## **Agenda Report**

Subject: September 12, 2016 Public Hearing on Highway 43 Plan Adoption

To consider adoption of the West Linn OR 43, 2016 Conceptual Design Plan as Attachment A to the 2016 West Linn Transportation System Plan (TSP) and associated amendments to cost estimates in the TSP, along with proposed amendments to Comprehensive Plan Goals 2, 11, and 12; and Community Development Code Chapters 46, 48, 55, 60, 85, and 92.

# 2016 Conceptual Design Plan

### Constrained Cross Section

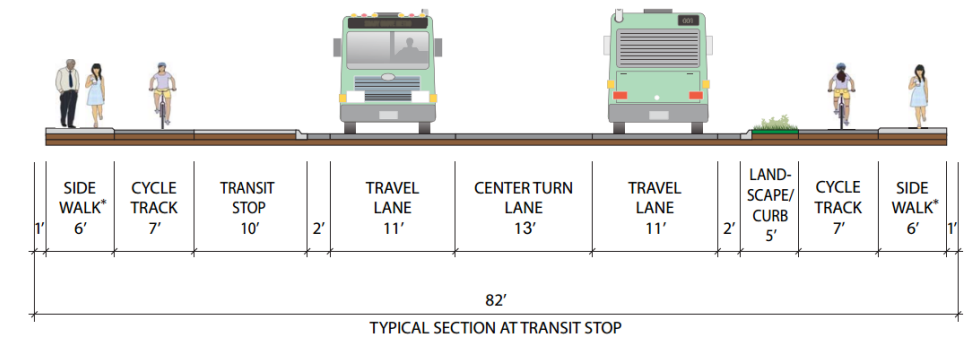
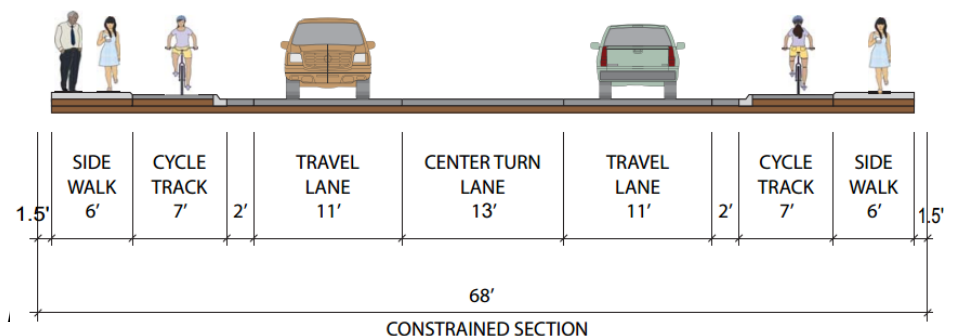
- 1) Add "Final design is subject to ODOT approval" to the cross-sections (shown on page 13) and Figures 1-22 of the concept plan. This will make clear the adoption of the concept plan does not constitute compliance with the Oregon Highway Design Manual and ODOT approval. While this is evident today we want to make sure it is clear in the future.

- The proposed cross-sections have two-tiers for the cycle track and sidewalk. Placing the sidewalk on a second tier may cause ADA challenges in design.
- The terrain may create challenges for ADA in design.
- A 3-foot shy from a vertical object and the edge of pavement of the cycle track should be used. The proposed cycle track in all of the cross-sections in Figure 2 does not provide a 3-foot shy from 3-foot regulatory/advisory signs and other vertical objects.

- Stormwater inlet design for the 'Constrained Cross-Section' in Figure 2 has challenges for maintenance and design.
- Space for sufficient water quality treatment.

1. Add "Final design is subject to ODOT approval" to the cross-sections (page 13) and Figures 1-22 of the concept plan.
2. Revise Project M35 (page 94 of the TSP) to read: Conduct a refinement plan to address the **Highway 43** projected 2040 unmet **ODOT** mobility standard at ~~Highway 43/Hidden Springs Road and Highway 43/I-205SB~~; **Marylhurst Dr.-Lazy River Way; Hidden Springs Rd.; Arbor Dr.; Pimlico Dr.; and Holmes St.**
3. Add the ODOT letters dated May 17, 2016 and August 18, 2016 to the adopted plan or plan appendix.
